Change Order | Allowance | Pay App Transmittal

PROJECT:	Ogdensburg City School District 2023 Capital Outlay Project 2023-008	DATE SENT:	11/3/2023
		RETURN BY:	11/14/2023
SUBJECT:	FO 104-03 Area 3 Subbase	CHANGE ORDER ALLOWANCE PAY APP ID:	01 (GC) AA-4- 003
TYPE:	Change Order Allowance Pay App	TRANSMITTAL ID:	00284
PURPOSE:	CO/AA For Signature to Owner	VIA:	FedEx/UPS
ACTUAL AMOUNT:	(\$24,070.44)	ESTIMATED AMOUNT:	(\$24,070.44)
ACTUAL DAYS:	0	ESTIMATED DAYS:	0

Project:	2023 Capital Outlay Project	Field Order No.:	104-03
Owner:	Ogdensburg City School District 1100 State Street Ogdensburg, New York 13669	Date:	September 29, 2023
Contractor:	D.C. Building Systems, Inc. 1015 Water Street Watertown, New York 13601	Architect's Project No.:	2023-008
SED No.:	51-23-00-01-0-007-025 OFA/Golden Dome	Contract For:	No. 1 - General Construction
		Contract Date:	July 3, 2023
		SED Project Manager:	Wendy Clark

RE: Ogdensburg Schools BC05 Parking Lot Undercut

SITE DEMOLITION PLAN - AREA	
BUILDING	SHEET NUMBER
1	L230

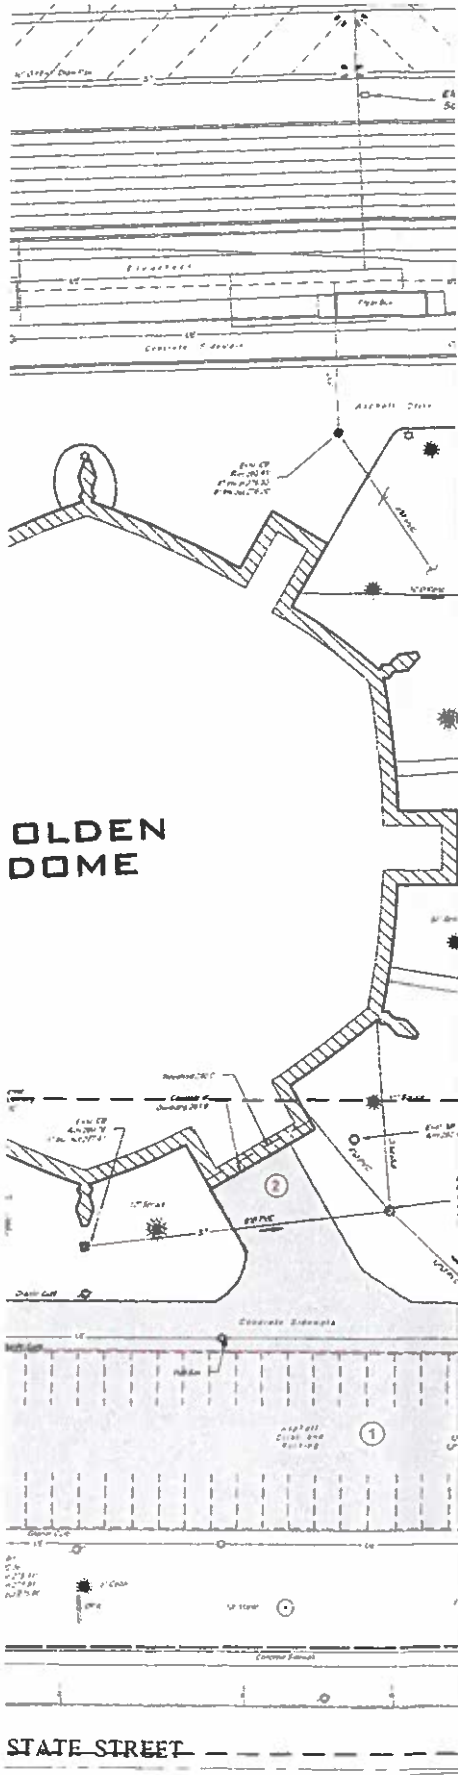
Add to provide labor, materials, and equipment to box out and replace 40'x80' area of wet subbase with 12-inches of compacted select stone and stabilization fabric at Are 3 adjacent to Storage Building No. 1. \$ 24,070.44

A	General Contractor
B	Under the Capital Outlay Project, the existing parking lot noted in Area 3 was scheduled for reconstruction as per Contract Drawings L230 and L330.
C	During removals, the General Contractor discovered a wet area of subbase in the southeast corner of the parking lot that was unsuitable to support the new pavement. As such, the wet material was removed and stabilization fabric installed to bridge the area prior to installing new compacted select stone.
D	Add to provide all labor, materials, and equipment to box out and replace 40'x80' area of wet subbase with 12-inches of compacted selected stone & stabilization fabric at Area 3 adjacent to Storage Building No. 1.

**SITE LAYOUT & GRADING
PLAN - AREA 3**

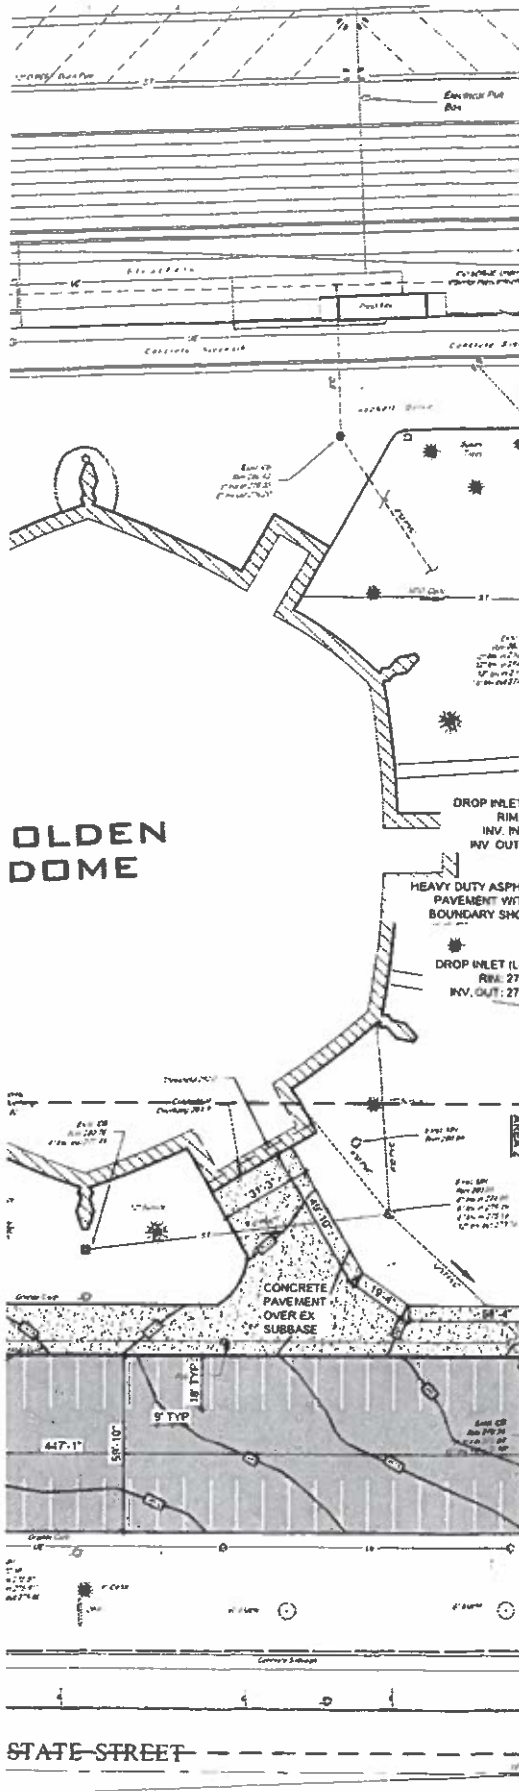
Following please find our proposal to perform additional undercut due to existing soil conditions. We boxed out the existing material to minus 12" add fabric and replace the existing material with type 2 stone compacted.

*Primary area Undercut 12" 40'x80' @ \$6.50/SF \$20,800

*A portion of the under-cut was still pumping so an additional 12'x40' area was undercut an additional 12" and type 2 stone was installed 480sf @ \$6.50/SF \$3,120
